**ALERT SERVICE BULLETIN**

**NO.** 427-08-22

**MODEL AFFECTED:** 427

**SUBJECT:** HYDRAULIC PUMP DRIVESHAFT ASSEMBLY  
P/N 406-040-072-105, ONE TIME INSPECTION OF

**Figure 1**  
**Hydraulic pump driveshaft assembly**

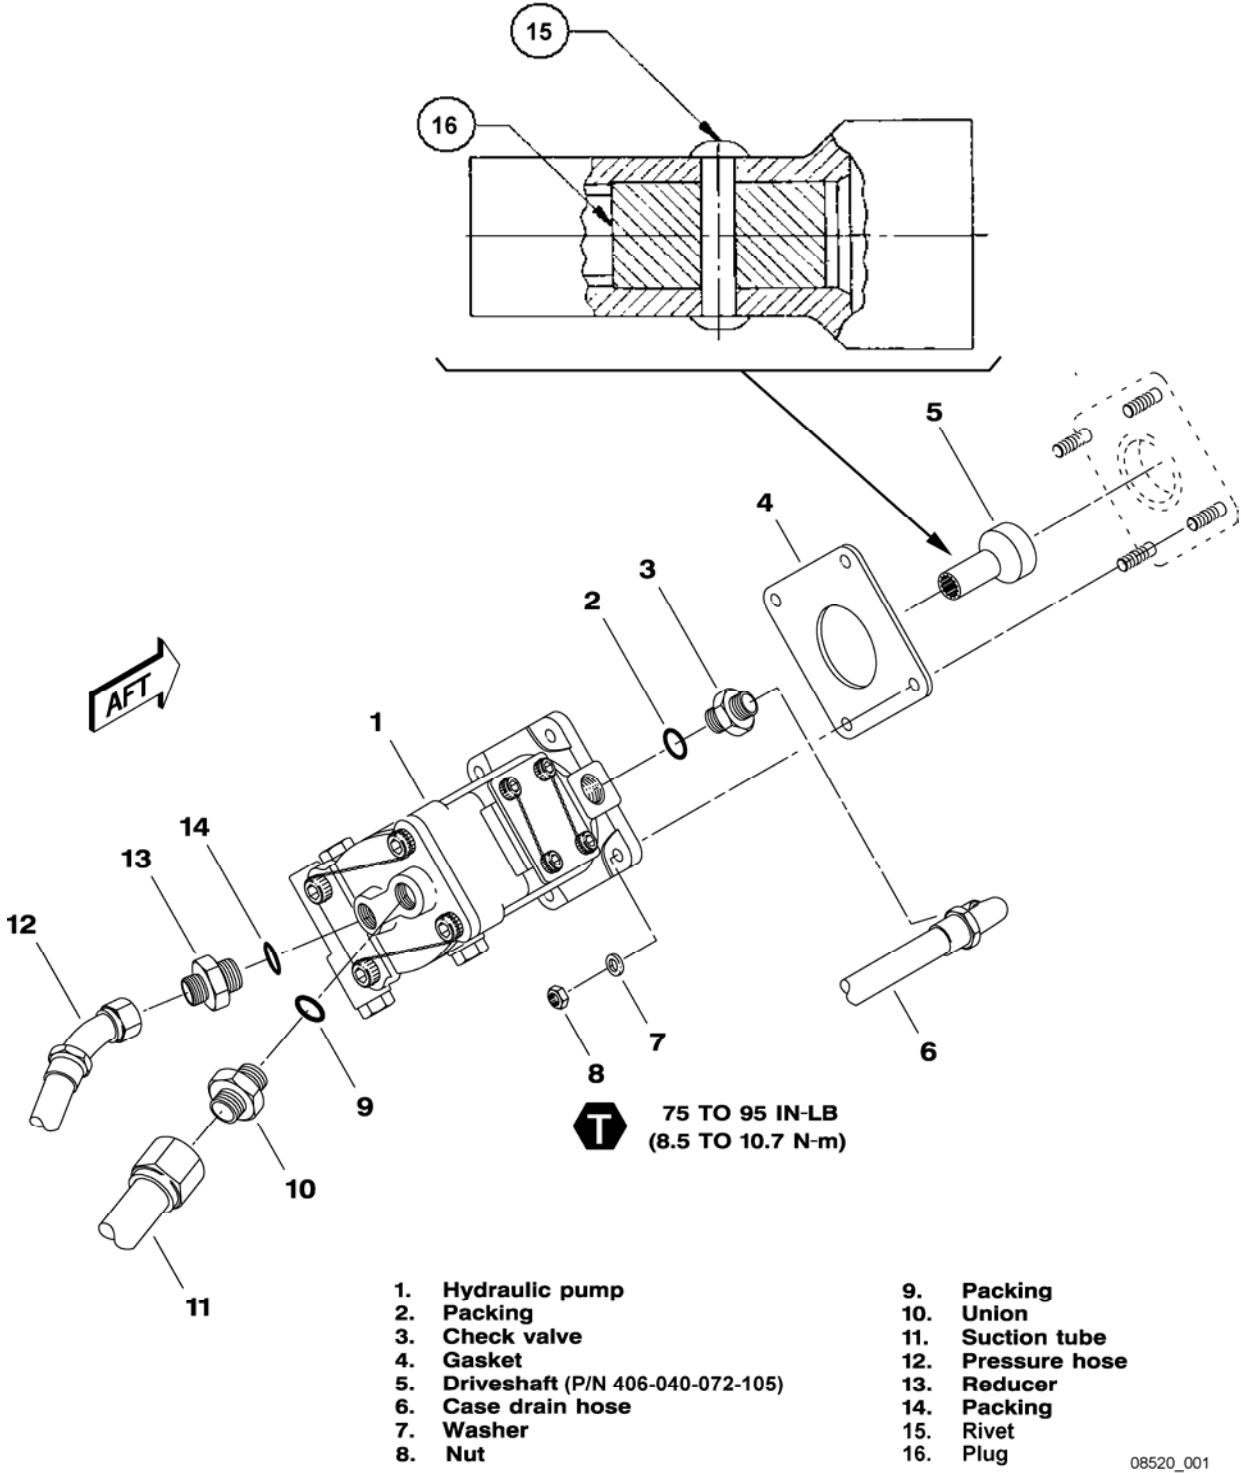
1. Gain access to the hydraulic pump P/N 206-076-030-ALL. Refer to the BHT-427-MM, chapter 29.
2. Remove hydraulic pump and driveshaft assembly P/N 406-040-072-105. Refer to figure 1 and to BHT-427-MM, Chapter 29.
3. Inspect hydraulic pump driveshaft assembly (item 5) for condition and missing rivet (item 15) or plug (item 16). Refer to figure 1 and BHT-427-MM, Chapter 29.

4. If rivet (item 15) or plug (item 16) are missing proceed as follow:
  - a. Submit a completed MMIR to BHTI Warranty Department.
  - b. Obtain parts listed in the material section of this bulletin and comply with Technical Bulletin 427-05-19.

- a. Inspect hydraulic pump driveshaft assembly (item 5) for missing rivet (item 15) or plug (item 16). Refer to figure 1.
  - b. If rivet (item 15) or plug (item 16) are missing. Submit a completed MMIR to BHTI Warranty Department and order parts listed in the Material section of this bulletin.

- c. If rivet (2) or plug (3) are not missing, attach a serviceable tag to the hydraulic pump driveshaft assembly (1) and write "THIS HYDRAULIC PUMP DRIVESHAFT ASSEMBLY COMPLIES WITH ASB 427-08-22".
